DEVELOPMENT REVIEW BOARD
SUPPLEMENTAL SUBMITTAL

PROJECT NO. PR-2021-005459
Application No. SD-2021-00163 SI-2021-01248

**RE: PR-2021-005459 RESPONSE TO DRB COMMENTS
LOT 1A BLOCK 2 & LOT 2-A-1 BLOCK 2 SUNPORT PARK
2900 TRANSPORT ST NE**

DRAWING TITLE
SITE PLAN

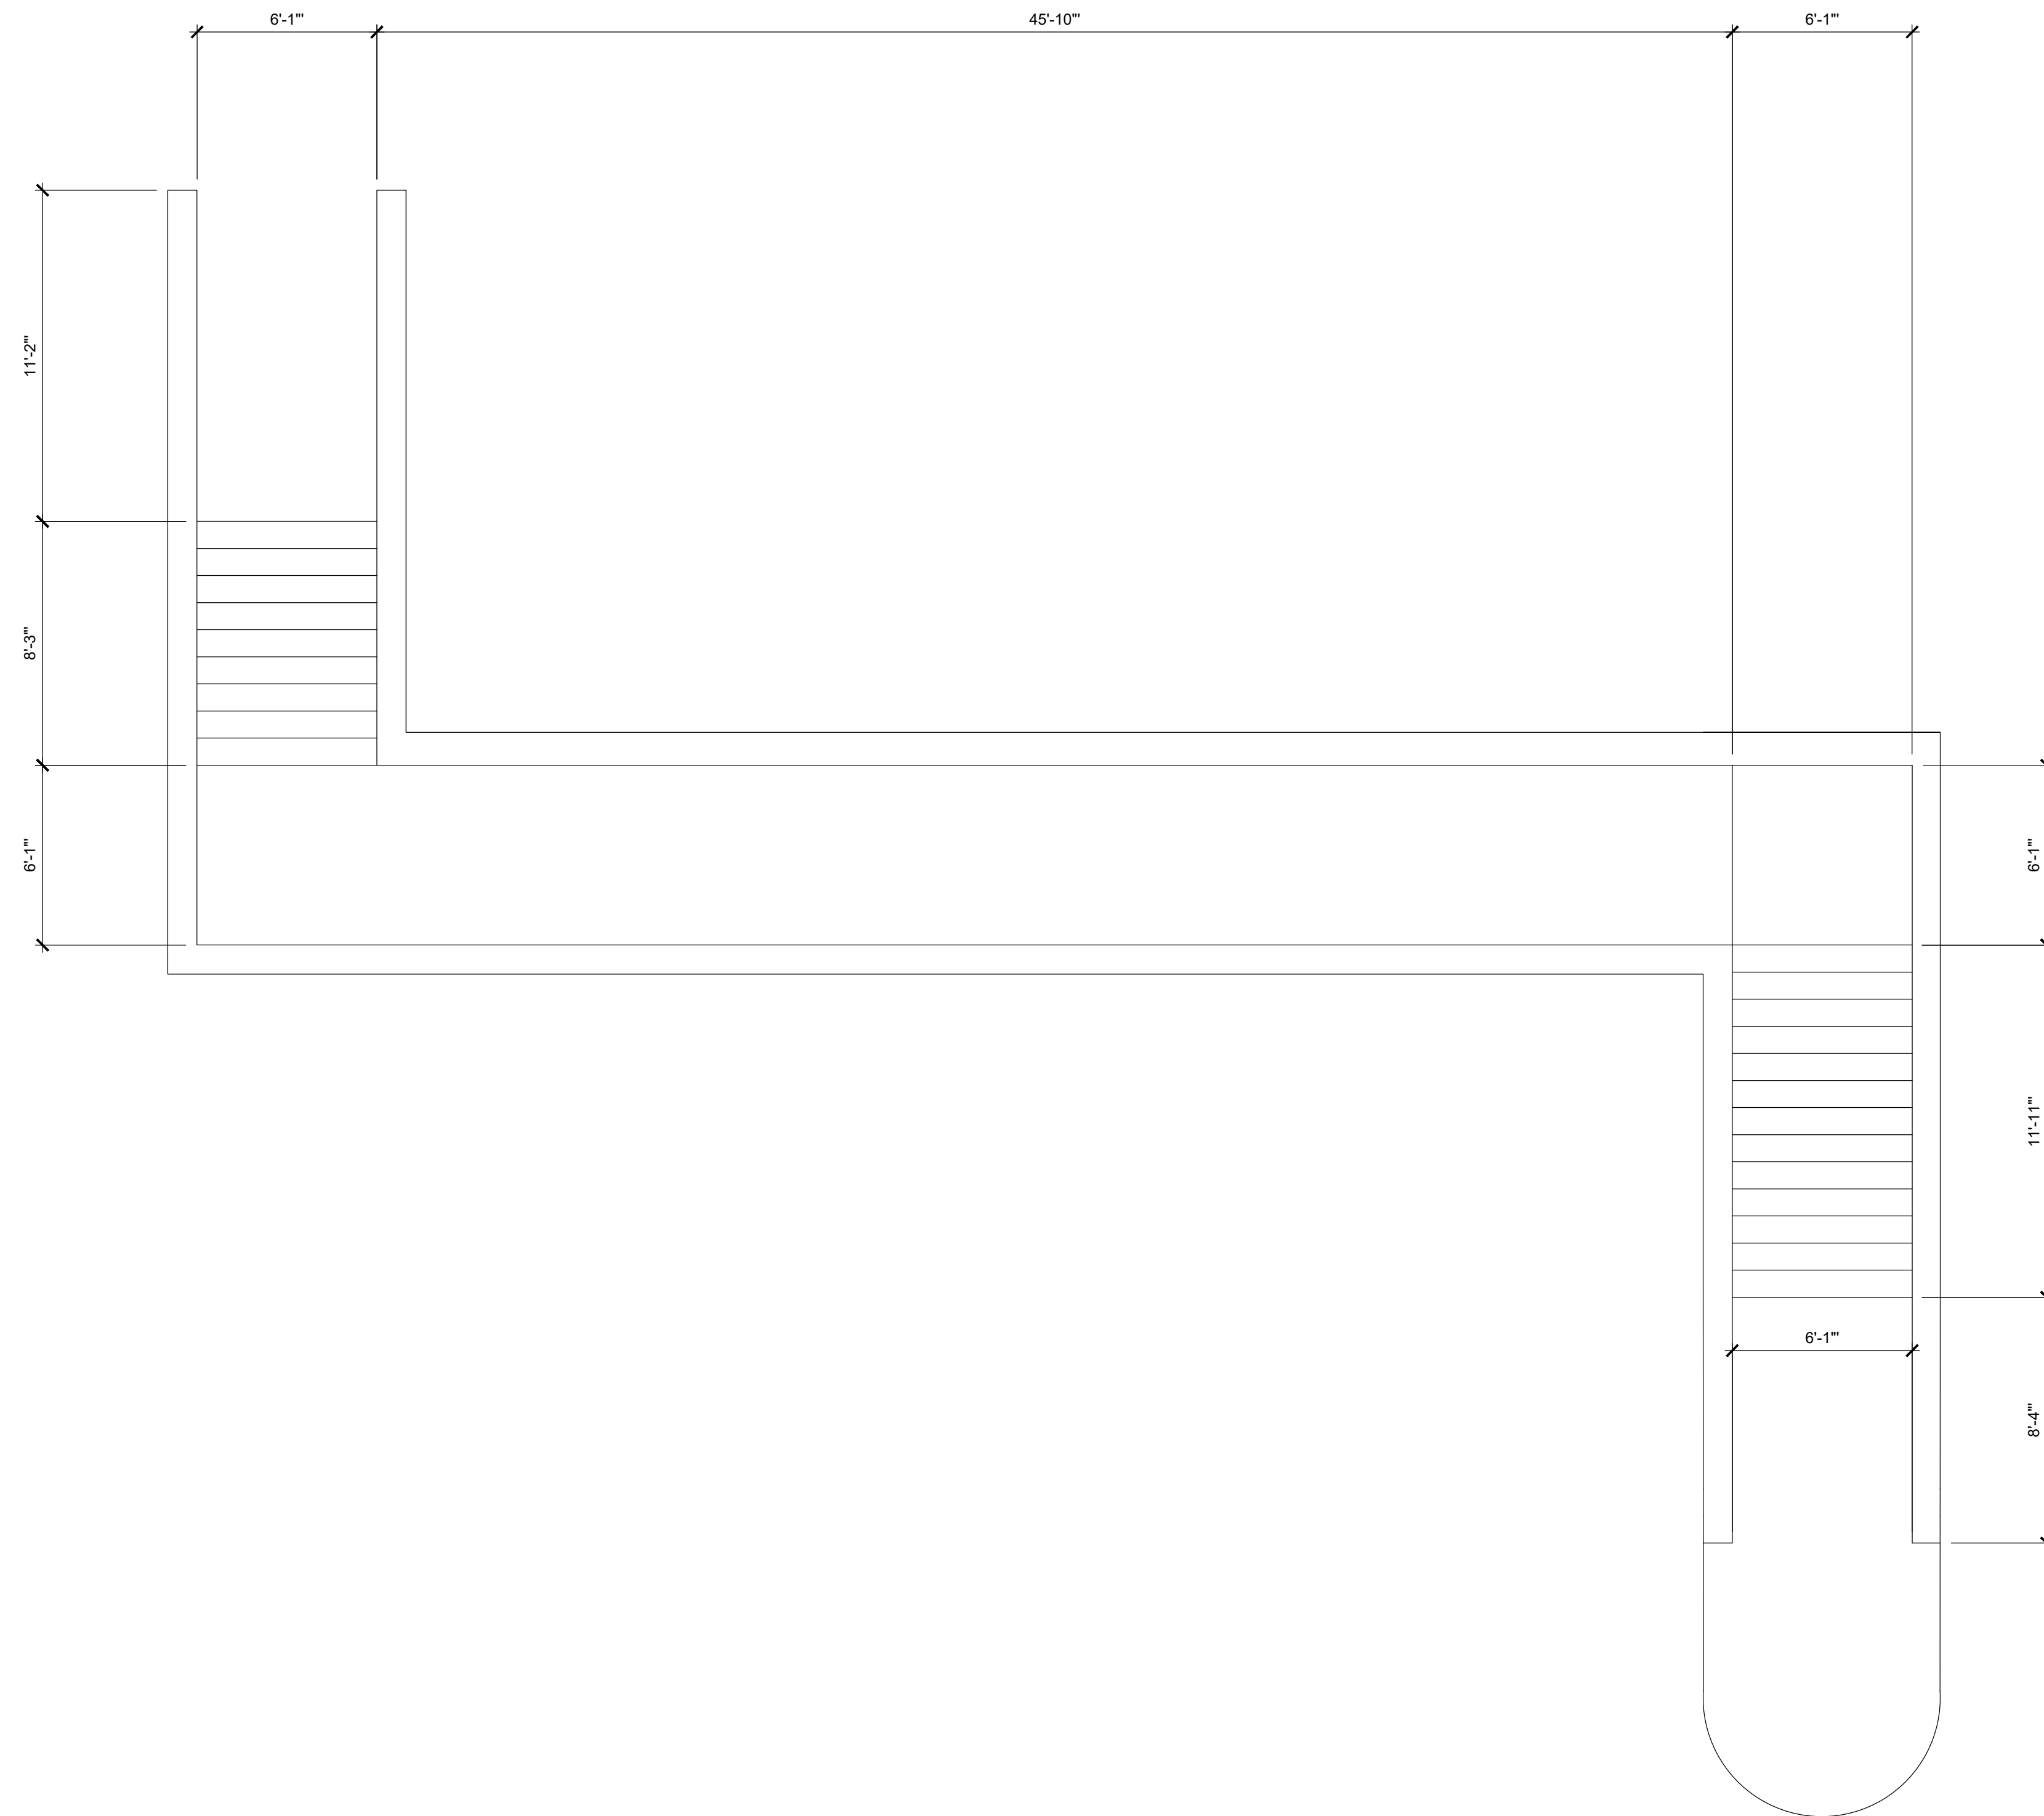
1. On the site plan, indicate the landscape buffer width between curb and sidewalk and/or provide a cross-sectional detail.
RESPONSE: 3'-6", reference revised keyed note U on A-001.

2. Include dimensioning for the motorcycle parking spaces, handicapped spaces, and van accessible aisles.
RESPONSE: Reference details sheet A-002.
3. Roadway dimensioning for the east access way is unclear. Because there are different dimensions for aisles, overall parking lot widths, and parking space lengths throughout the site, label typical dimensioning for each of the parking lot segments. (One of the dimensions for the access ways is shown in the thousands.) Shows curb radii near the Building 500 where the driving aisles make a 90-degree turn.

8. An incorrect curb ramp detail reference is made on Keyed Note W. Make sure all ramps on-site are called out. Call out all ramps on the plan at the van accessible aisles, crosswalk aisles, etc. Make sure that the crosswalks line up with the sidewalks.

9. Along the north side, the van accessible aisles are not adjacent to sidewalk for ADA access (far north side near the north access way).

2. Please state the height of the CMU wall depicted as Note J on the Site plan. The comment response letter notes that an 8-foot retaining wall is proposed. The City Engineer needs to approve of the 8-foot retaining wall height as depicted on the Site Plan.

RESPONSE: Additional dimensions provided.
4. Regarding the detail for the stairway to the western right-of-way, include details for the entire layout including the number of steps, dimensions of landings, slopes along the straight sections, etc.

RESPONSE: Turn down sidewalk will be used reference revised keyed note K.

RESPONSE: Reference change, see keyed note W. Crosswalk alignment corrected west of building 500.

RESPONSE: The ADA spaces in question are within the underground parking structure. After some correspondence with Jeanne Wolfenbarger on this, the ADA parking in this area has been adjusted to have a 4' wide adjacent accessible route to the elevators in this parking structure. See Floor Plan sheet A-104.1, the footprint of the underground parking floor will actually have a "bump-out" for this accessible route that the first floor of the building does not have, as depicted on the site plan sheet.

RESPONSE: Wall heights called out in the plan view.
3. Lighting and light poles need to be noted and depicted on the Site Plan to ensure conformance with 5-8 of the IDO.

| <p>DRAWING TITLE: SITE DETAILS</p> | | |

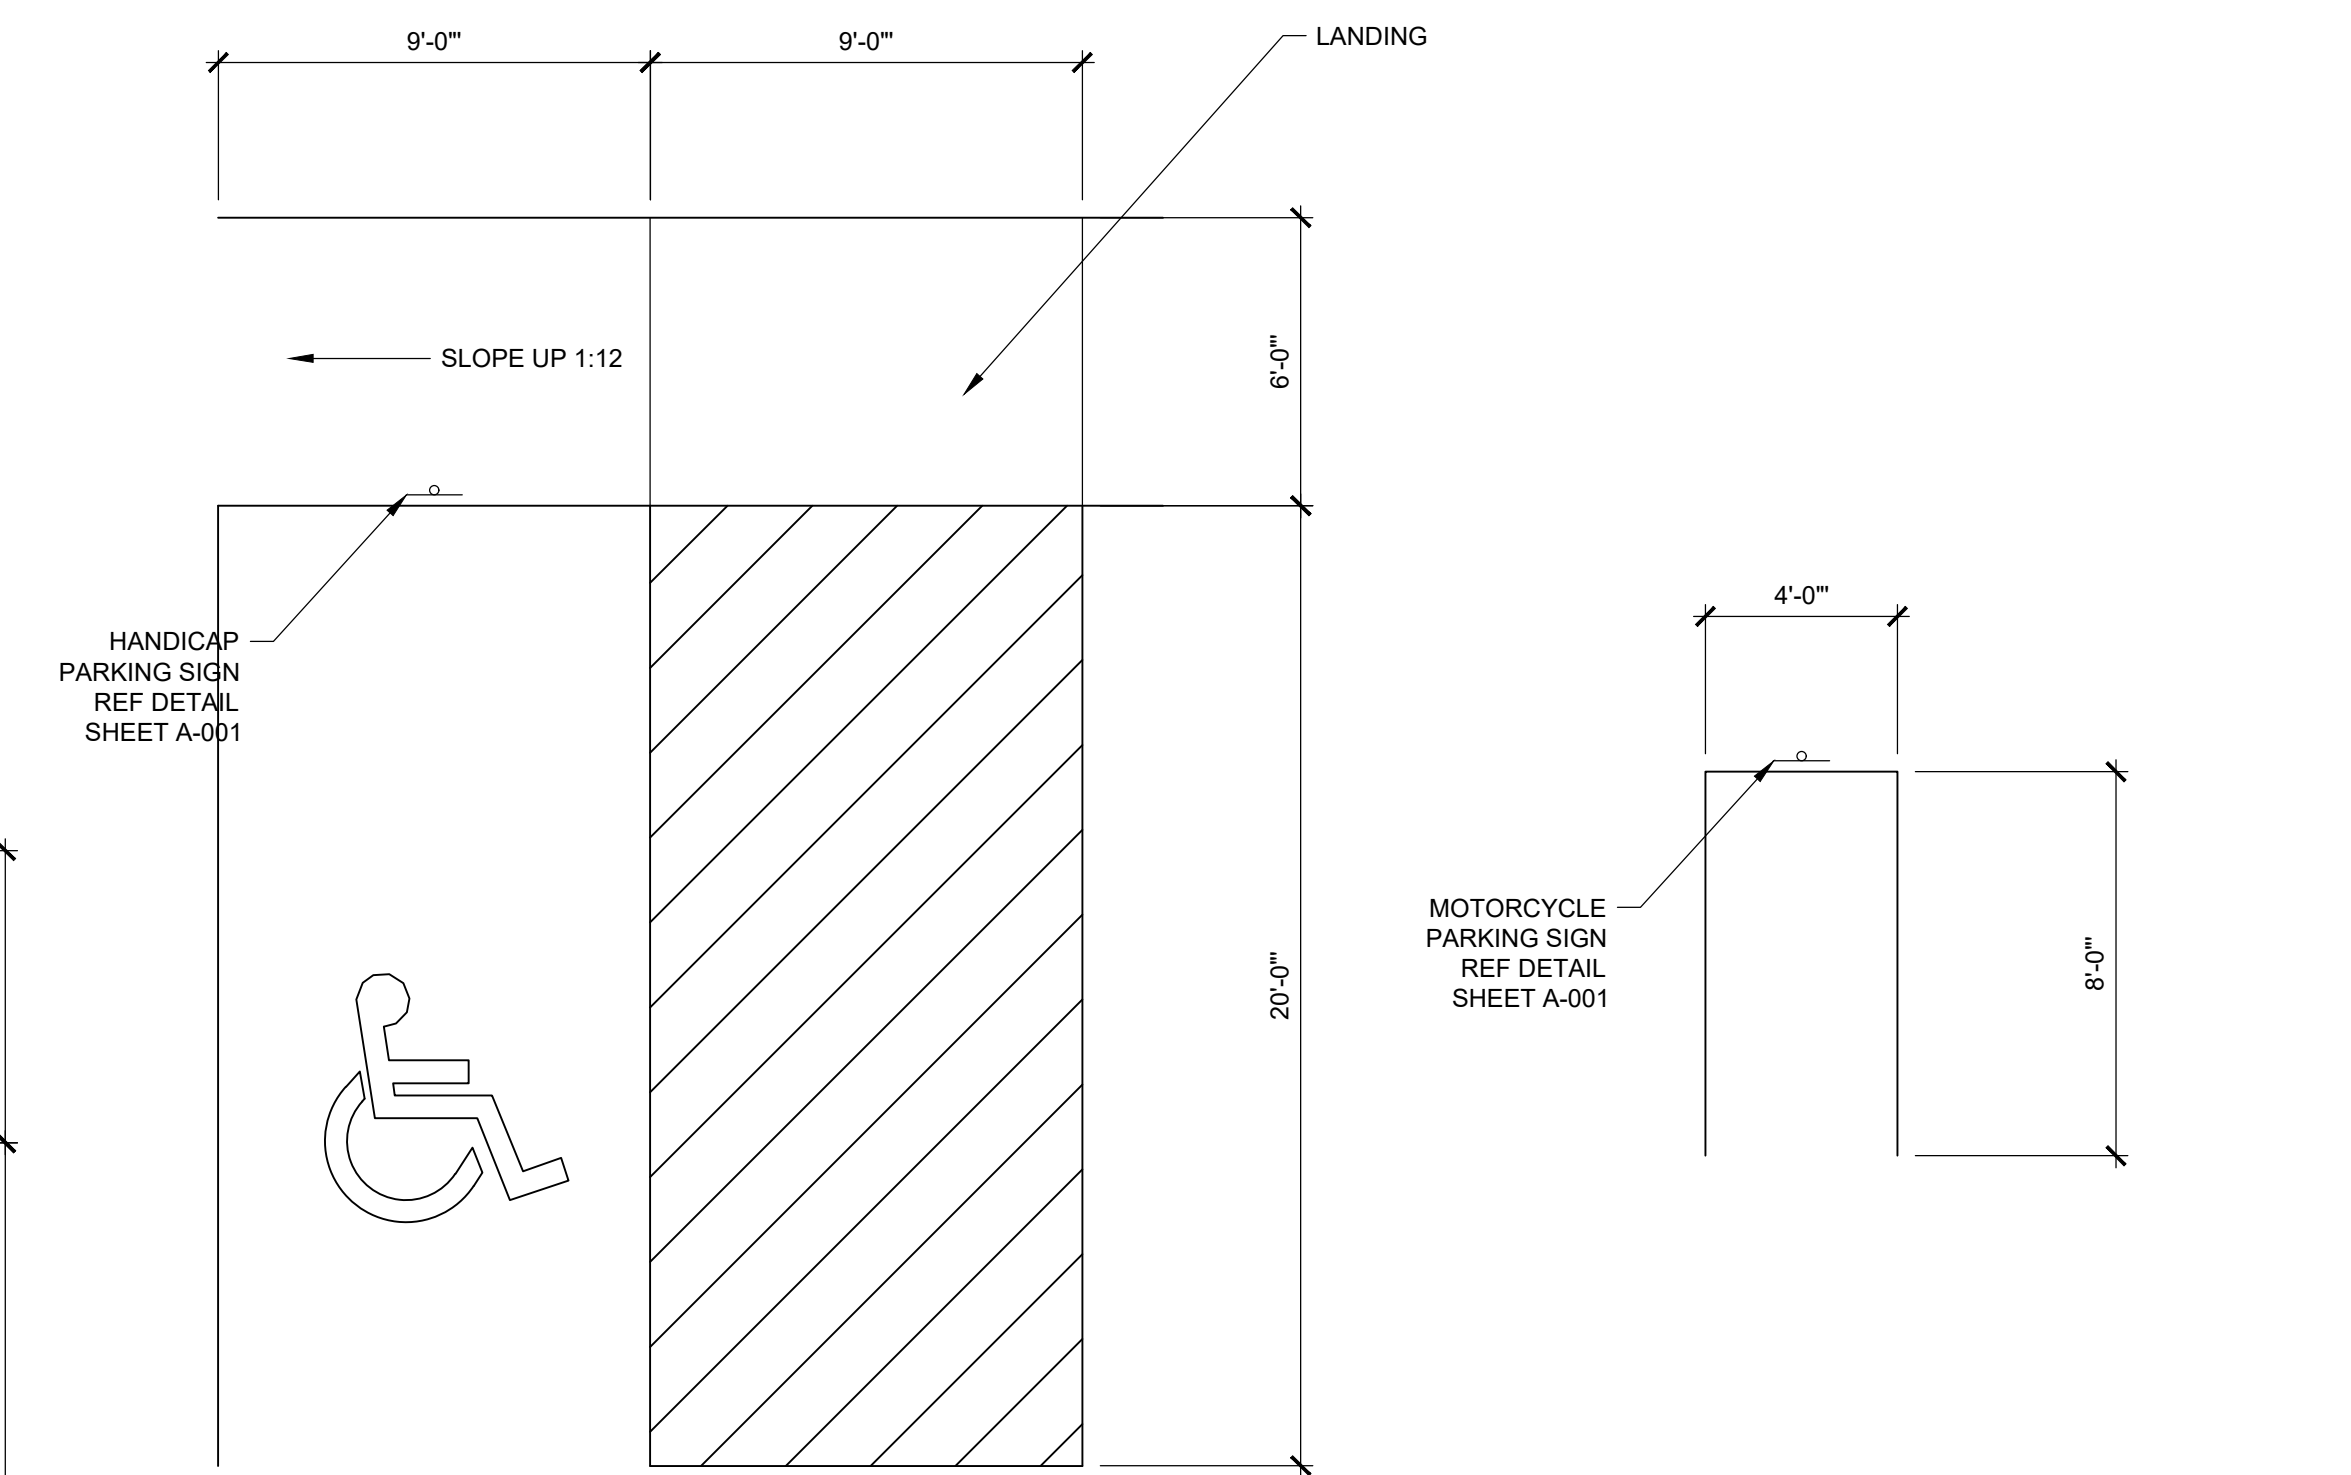
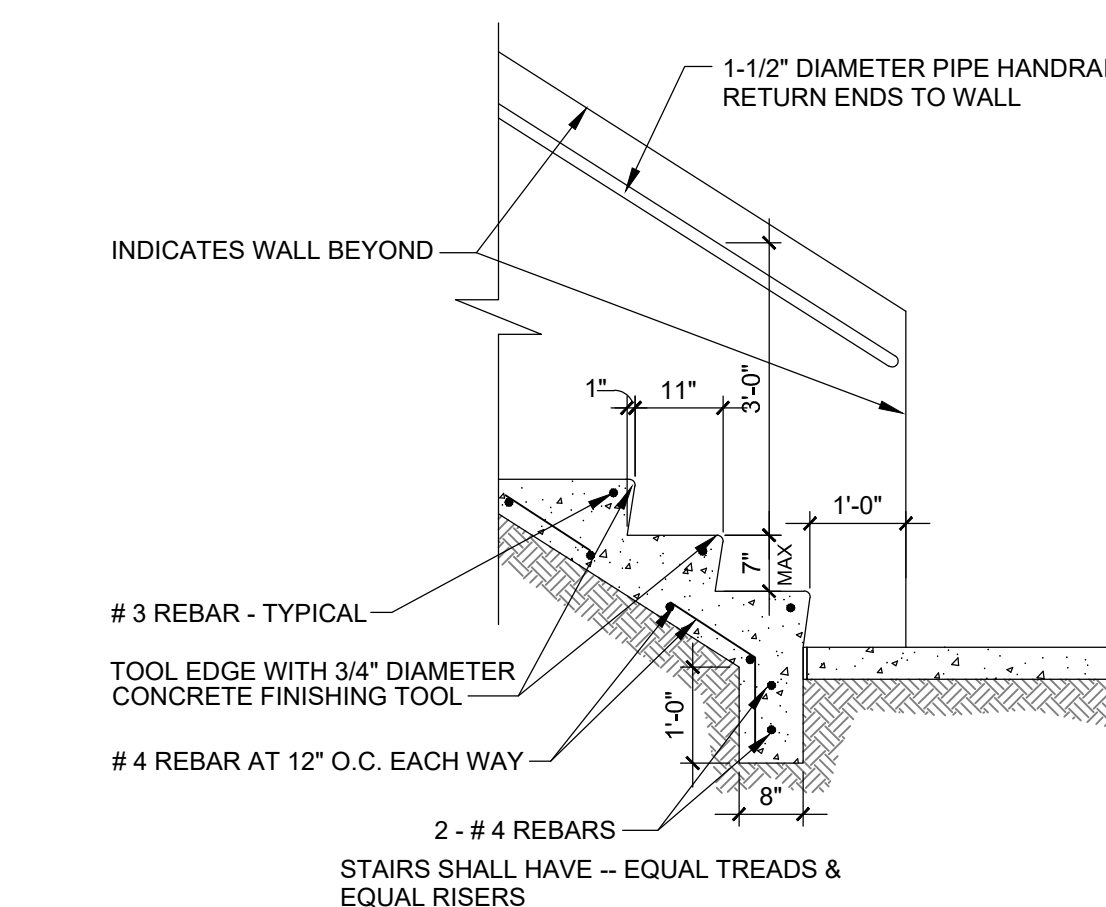
7. For curb ramp reference detail 2443, dimensioning of landing shall also be provided. It would be helpful to provide a detail showing handicapped spaces with the van accessible aisles since this is pretty typical.

RESPONSE: Detail added to A-002.
5. Dimension parking lot keyway by Club House 800.
RESPONSE: Dimension added.
6. Clarify if turn-down sidewalk edge will be built along the parking lot or if header curb is adjacent to the sidewalk.

RESPONSE: Reference detail B5 / A-002
